STATE OF WASHINGTON
DEPARTMENT OF ECOLOGY

January 17, 2020

The Department of Ecology (Ecology) appreciates the progress the Landsburg Mine Site PLP Group has made in the cleanup of this site. Ecology also appreciates the additional actions taken by the PLP Group to address the 1,4-Dioxane detected at a few of the monitoring wells located at the former north portal of the site. To date, the 1,4-Dioxane concentrations range from 1.5 µg/L to 2.3 µg/L, at two compliance monitoring wells (LMW-2 and LMW-4) and one sentinel well (LMW-12).

FIGURE A-8
**REMEDIAL ACTION TRIGGERS FOR DETECTIONS
 AT SENTINEL AND COMPLIANCE WELLS**
 PALMER/LANDBURG MINE/WA

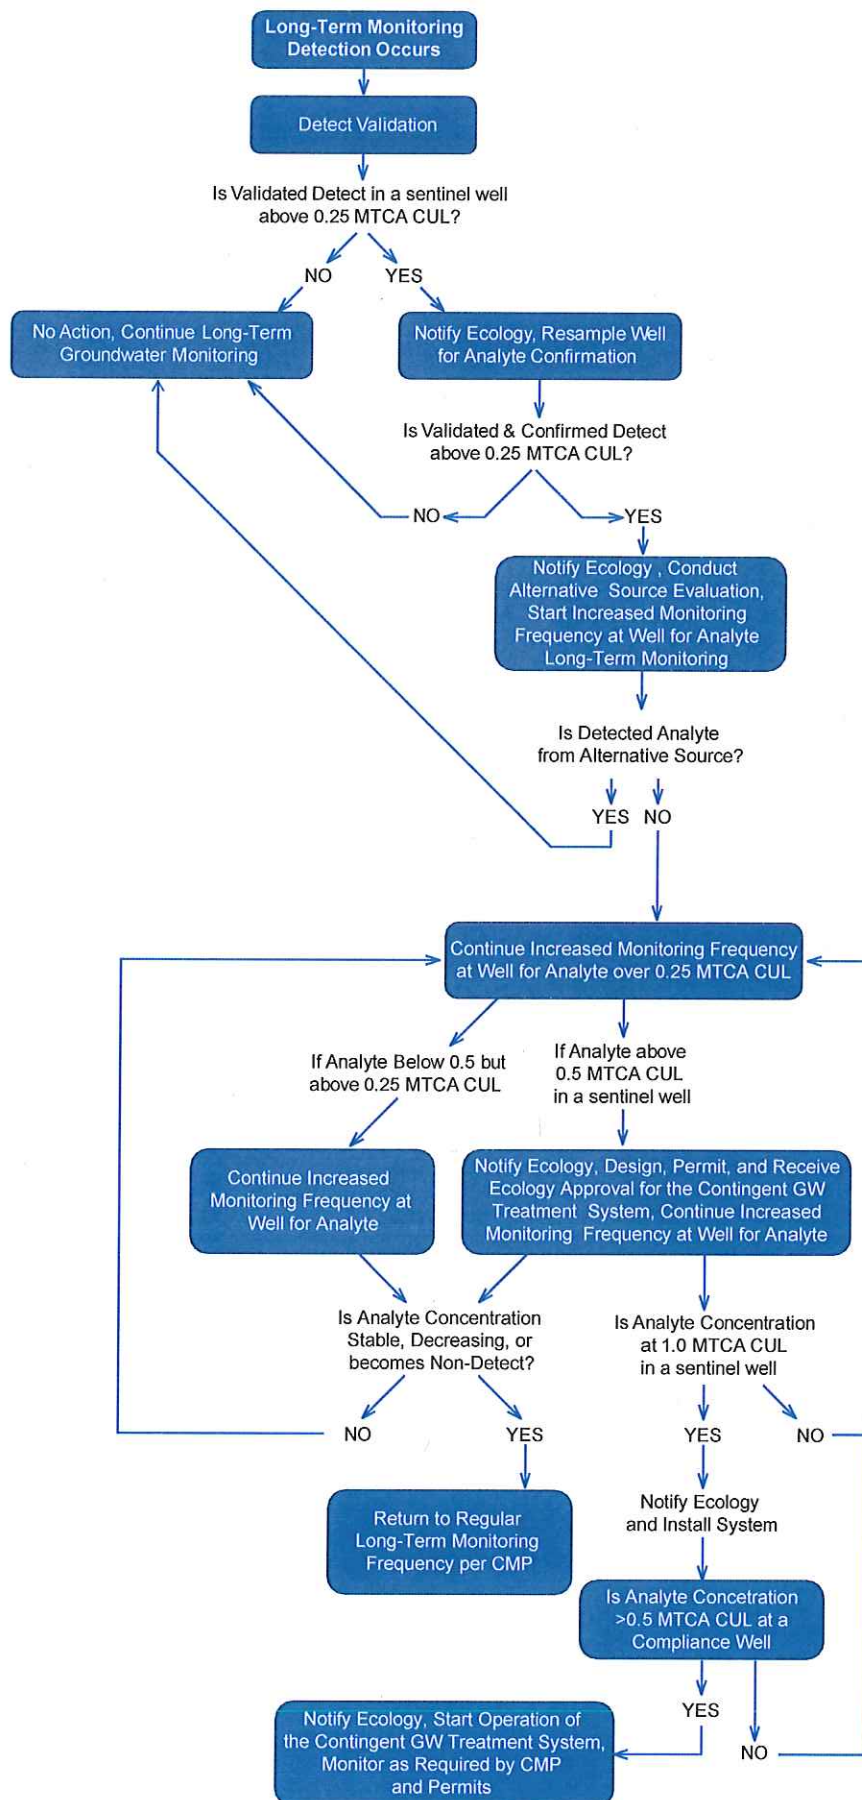
According to Exhibit D of the Cleanup Action Plan (Compliance Monitoring Plan), an exceedance of a COC above the MTCA cleanup level and/or fractions thereof (0.25 times and 0.5 times) triggers various requirements for implementing contingency actions (see attached figures). Based on the sampling data provided to date, Ecology has determined that the

following concentration thresholds (triggers for remedial action) have been exceeded at the north portal wells as seen in this annotated Table A-4 from the Compliance Monitoring Plan:

Because the above exceedances have been verified and no alternative source of the contamination has been identified, the Consent Decree requires the PLPs to begin implementing contingency actions pursuant to the Contingent Groundwater Extraction and Treatment System Plan (Exhibit D, Part C). See Consent Decree Section VI.A.4 and Exhibit D, Part A, at A-6 (step

#6). The first step involves designing an extraction and treatment system that is tailored to the 1,4-Dioxane contamination detected in monitoring wells LMW-2, LMW-4, and LMW-12.

Pursuant to the Contingent Groundwater Extraction and Treatment System Plan (Exhibit D, Part C), the PLP Group must submit a draft Engineering Design Report (EDR) and contingent system-specific Operation and Maintenance (O&M) Plan for Ecology's review and approval within 30 days.
